**NEW YORK STATE THRUWAY AUTHORITY
DEPARTMENT OF ENGINEERING**

**AMENDMENT NO. 1
TO**

**CONTRACT TAS 24-5B
D214950
REHABILITATION OF THE I-90 EB & I-90 WB
BRIDGES OVER STERLING CREEK AT
MILEPOSTS 227.40 AND 227.41
IN THE SYRACUSE DIVISION
OF THE NEW YORK STATE THRUWAY
IN HERKIMER COUNTY**

CONTRACT NUMBER: TAS 24-5B
 DATE: NOV. 2023
 DRAWING NUMBER: TYP-2

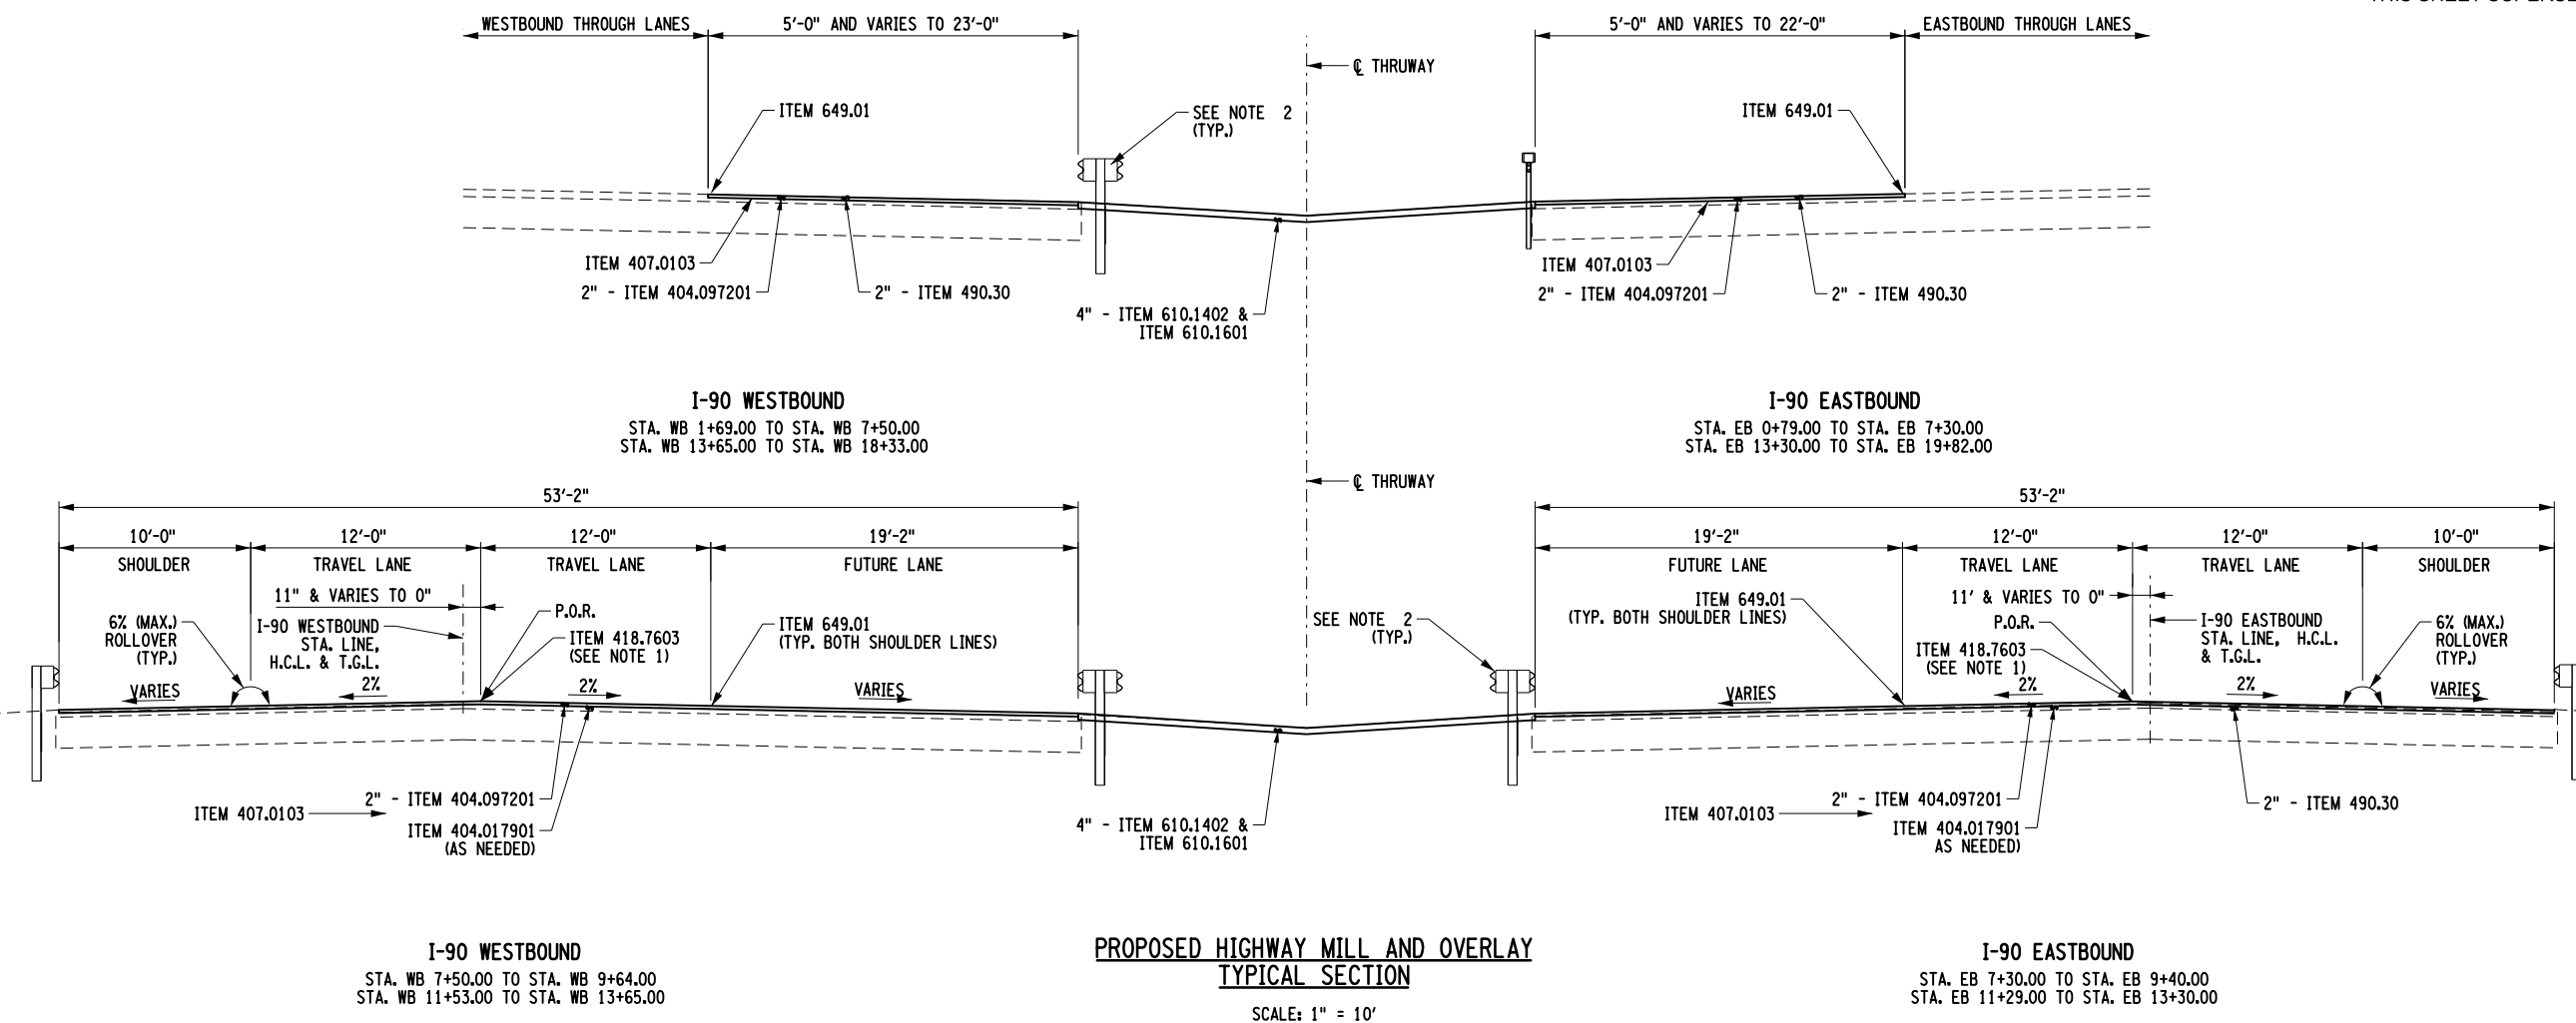
3. **DELETE** Drawing Number TYP-2, Sheet 38 of 87, and **REPLACE** with Drawing Number TYP-2, Sheet 38-A1 of 87.
 - Reference to Item 404.017901 was added and other items not previously shown in the details were removed from the Items Table.

- A Median Restoration Detail for the proposed temporary paved median has been provided in the bottom middle of the plan sheet.
4. **DELETE** Drawing Number GP-1, Sheet 43 of 87, and **REPLACE** with Drawing Number GP-1, Sheet 43-A1 of 87.

TITLE OF PROJECT STERLING CREEK BRIDGE REHABILITATION	CONTRACT NUMBER: TAS 24-5B
	LOCATION OF PROJECT SYRACUSE DIVISION BIN 5516091 & 5516092 MP 227.40 & MP 227.41	DATE: NOV. 2023
	TITLE OF DRAWING GENERAL PLAN	DRAWING NUMBER: GP-1

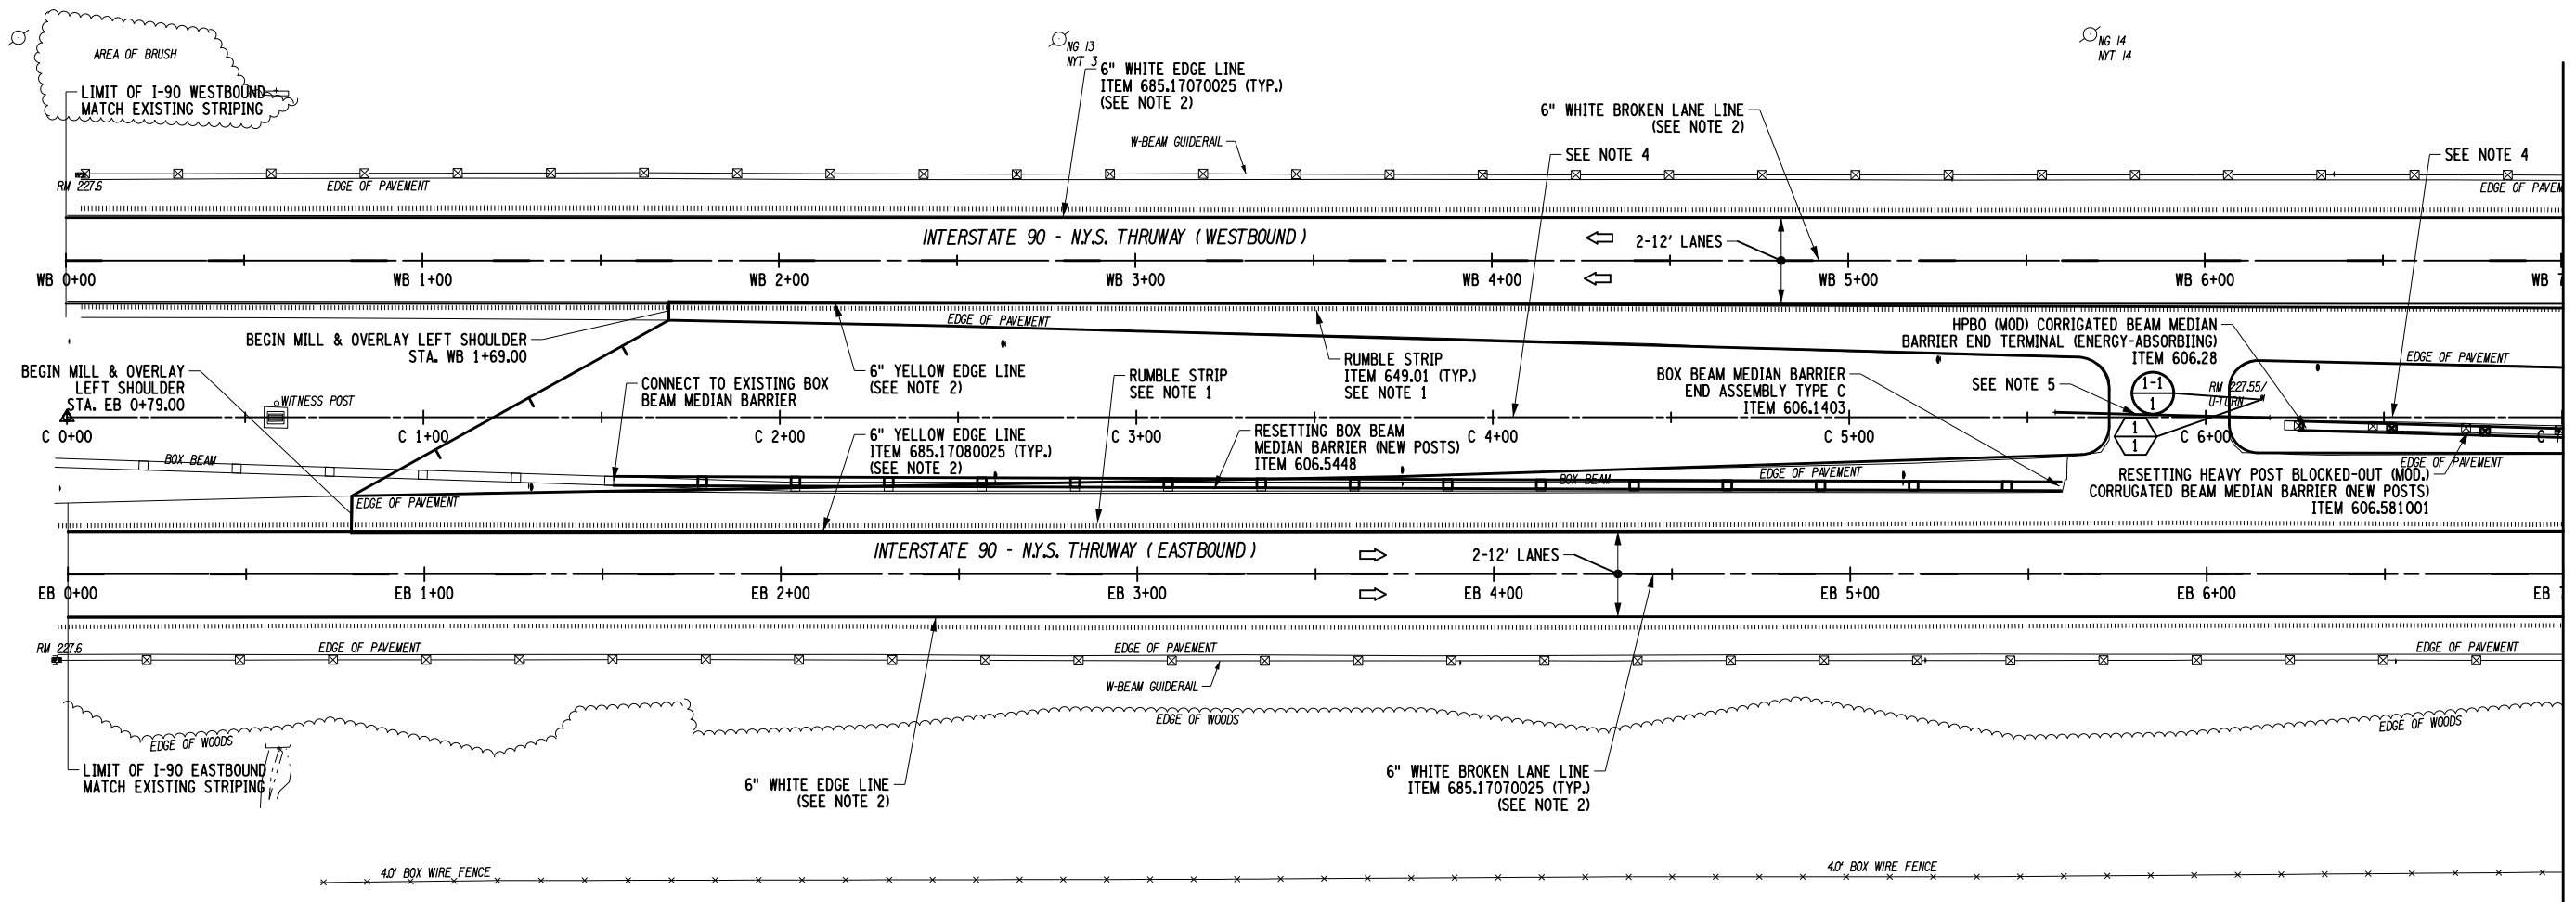
- New Notes 4 and 5 have been added. The limits and intent of proposed work has been clarified and applicable pay items have been identified. Reference is made to the Median Restoration Detail as provided in amended Drawing Number TYP-2, Sheet 38-A1 of 87, attached herein.

- SEE DWG. NO. MT-1 FOR GUIDERAIL TABLE & REFERENCE MARKER TABLE
- UPON COMPLETION OF CONSTRUCTION, CONTRACTOR SHALL REMOVE PROPOSED TEMPORARY MEDIAN PAVING AND RE-ESTABLISH EXISTING PRE-CONSTRUCTION GRASS MEDIAN. CONTRACTOR SHALL ENSURE POSITIVE DRAINAGE IN ACCORDANCE WITH PRE-CONSTRUCTION CONDITIONS. COST OF REMOVAL OF TEMPORARY MEDIAN PAVING, GRADING OF MEDIAN, AND ESTABLISHMENT OF TOPSOIL AND TURF TO BE INCLUDED IN ITEMS 203.02, 610.1402 AND 610.1601. SEE DETAIL ON DWG. TYP-2 A1.

- CONTRACTOR TO MILL AND OVERLAY U-TURN AREA IN SIMILAR FASHION TO DETAILS ON DWG. TYP-2 A1. CONTRACTOR TO REESTABLISH 60' CROSS CULVERT PIPE FROM STA C 5+58, 1.4' LEFT, INV. ELEV. 431.71 TO STA C 6+18, 0.1' RIGHT, INV. ELEV. 431.62. COST OF CUTTING PAVEMENT, EXCAVATION, CORRUGATED STEEL PIPE, END SECTIONS, BACKFILL AND SUBBASE, AND BINDER SHALL BE INCLUDED IN ITEMS 627.50140008, 203.02, 603.051116, 603.171116, 304.12, AND 404.197901.

Thruway Authority 	TITLE OF PROJECT STERLING CREEK BRIDGE REHABILITATION	CONTRACT NUMBER: TAS 24-5B
	LOCATION OF PROJECT SYRACUSE DIVISION BIN 5516091 & 5516092 MP 227.40 & MP 227.41	DATE: NOV. 2023
	TITLE OF DRAWING GENERAL PLAN	DRAWING NUMBER: GP-2

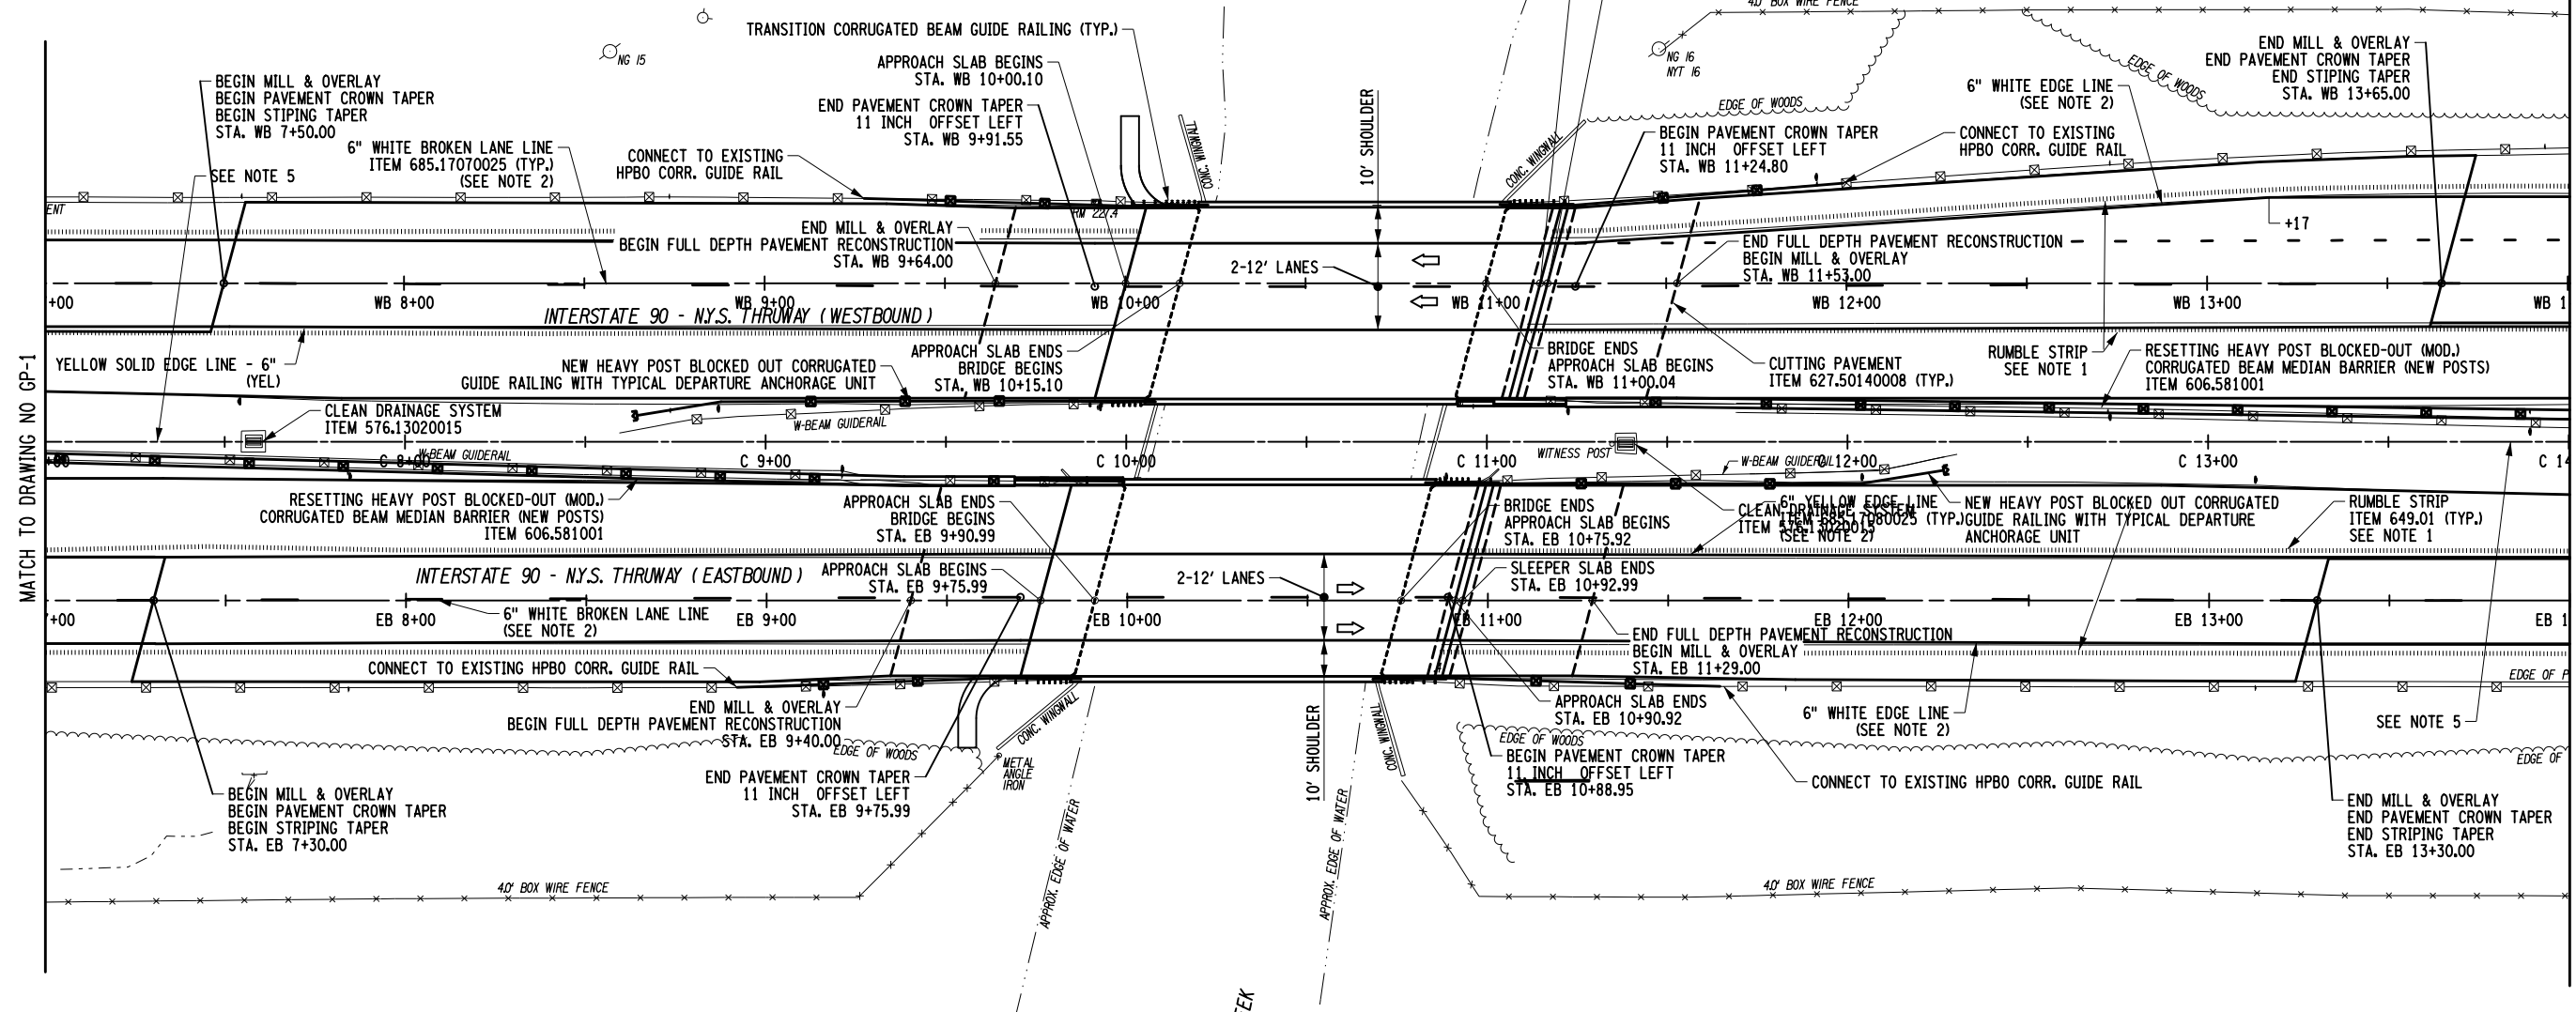
5. **DELETE** Drawing Number GP-2, Sheet 44 of 87, and **REPLACE** with Drawing Number GP-2, Sheet 44-A1 of 87.
 - New Note 5 has been added. Reference is made to the Median Restoration Detail as provided in amended Drawing Number TYP-2, Sheet 38-A1 of 87, attached herein.

- REFER TO NYSDOT STANDARD SHEET 649-02 FOR DETAILS OF MILLED IN AUDIBLE ROADWAY DELINEARS (MIARDS).
- UNLESS OTHERWISE NOTED, ALL MAINLINE PAVEMENT MARKINGS SHALL BE HIGHLY REFLECTORIZED TRIPLE DROP EPOXY PAVEMENT STRIPES, INCLUDING RIGHT AND LEFT EDGE LINES & BROKEN LANE LINES.
- WHITE BROKEN LANE LINE SHALL FOLLOW CROWN TAPER AND 11" OFFSET.
- SEE DWG. NO MT-1 FOR GUIDERAIL TABLE & REFERENCE MARKER TABLE
- UPON COMPLETION OF CONSTRUCTION, CONTRACTOR SHALL REMOVE PROPOSED TEMPORARY MEDIAN PAVING AND RE-ESTABLISH EXISTING PRE-CONSTRUCTION GRASS MEDIAN. CONTRACTOR SHALL ENSURE POSITIVE DRAINAGE IN ACCORDANCE WITH PRE-CONSTRUCTION CONDITIONS. COST OF REMOVAL OF TEMPORARY MEDIAN PAVING, GRADING OF MEDIAN, AND ESTABLISHMENT OF TOPSOIL AND TURF TO BE INCLUDED IN ITEMS 203.02, 610.1402 AND 610.1601. SEE DETAIL ON DWG. TYP-2 A1.

Thruway Authority	TITLE OF PROJECT STERLING CREEK BRIDGE REHABILITATION	CONTRACT NUMBER: TAS 24-5B
	LOCATION OF PROJECT SYRACUSE DIVISION BIN 5516091 & 5516092, MP 227.40 & MP 227.41	DATE: NOV. 2023
	TITLE OF DRAWING GENERAL PLAN	DRAWING NUMBER: GP-3

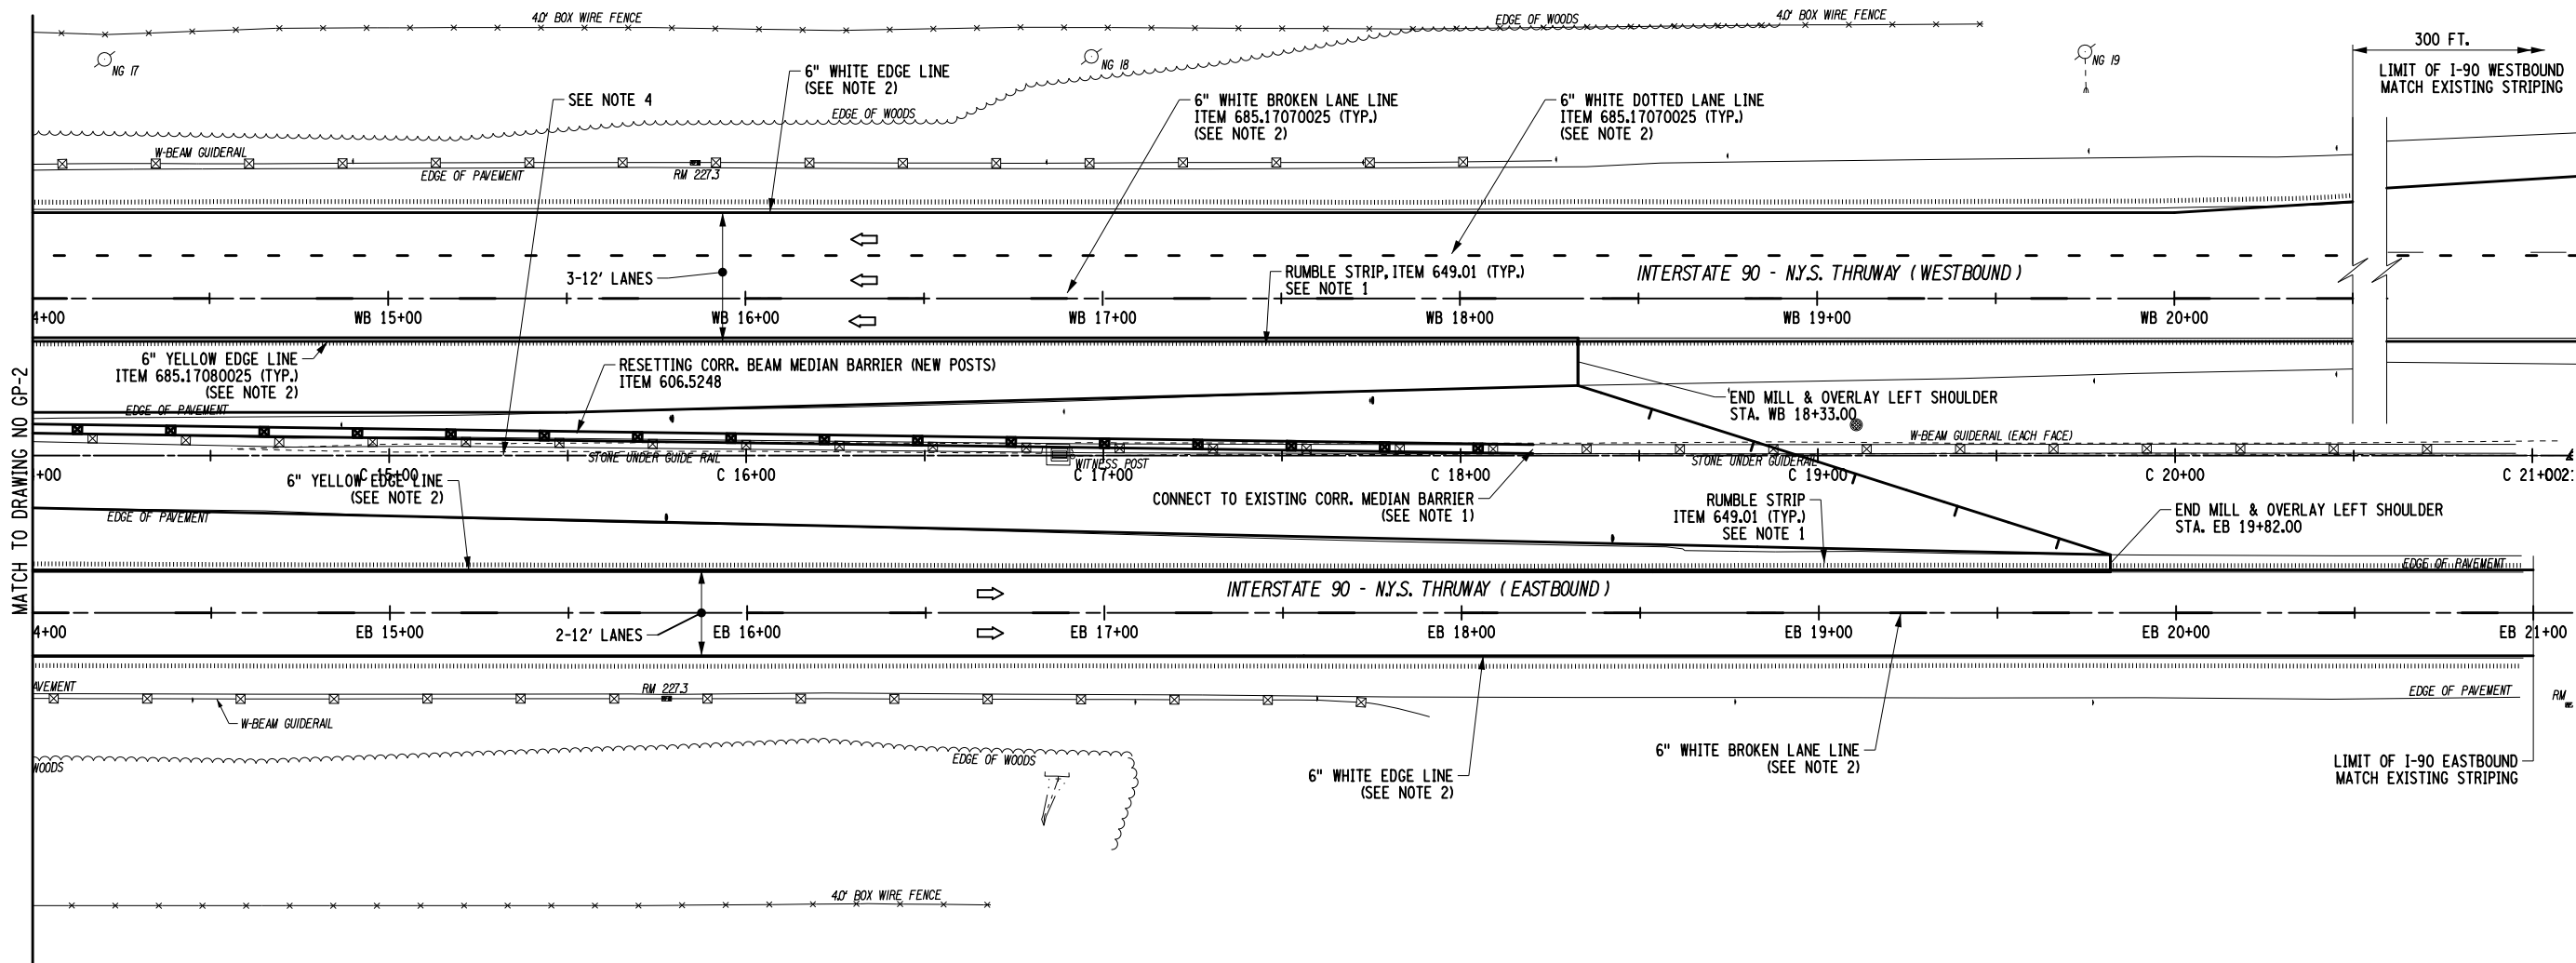
6. **DELETE** Drawing Number GP-3, Sheet 45 of 87, and **REPLACE** with Drawing Number GP-3, Sheet 45-A1 of 87.
 - New Note 4 has been added. Reference is made to the Median Restoration Detail as provided in amended Drawing Number TYP-2, Sheet 38-A1 of 87, attached herein.

- REFER TO NYSDOT STANDARD SHEET 649-02 FOR DETAILS OF MILLED IN AUDIBLE ROADWAY DELINEARS (MIARDS).
- UNLESS OTHERWISE NOTED, ALL MAINLINE PAVEMENT MARKINGS SHALL BE HIGHLY REFLECTORIZED TRIPLE DROP EPOXY PAVEMENT STRIPES, INCLUDING RIGHT AND LEFT EDGE LINES & BROKEN LANE LINES.
- SEE DWG. NO. MT-1 FOR GUIDERAIL TABLE & REFERENCE MARKER TABLE
- UPON COMPLETION OF CONSTRUCTION, CONTRACTOR SHALL REMOVE PROPOSED TEMPORARY MEDIAN PAVING AND RE-ESTABLISH EXISTING PRE-CONSTRUCTION GRASS MEDIAN. CONTRACTOR SHALL ENSURE POSITIVE DRAINAGE IN ACCORDANCE WITH PRE-CONSTRUCTION CONDITIONS. COST OF REMOVAL OF TEMPORARY MEDIAN PAVING, GRADING OF MEDIAN, AND ESTABLISHMENT OF TOPSOIL AND TURF TO BE INCLUDED IN ITEMS 203.02, 610.1402 AND 610.1601. SEE DETAIL ON DWG. TYP-2 A1.
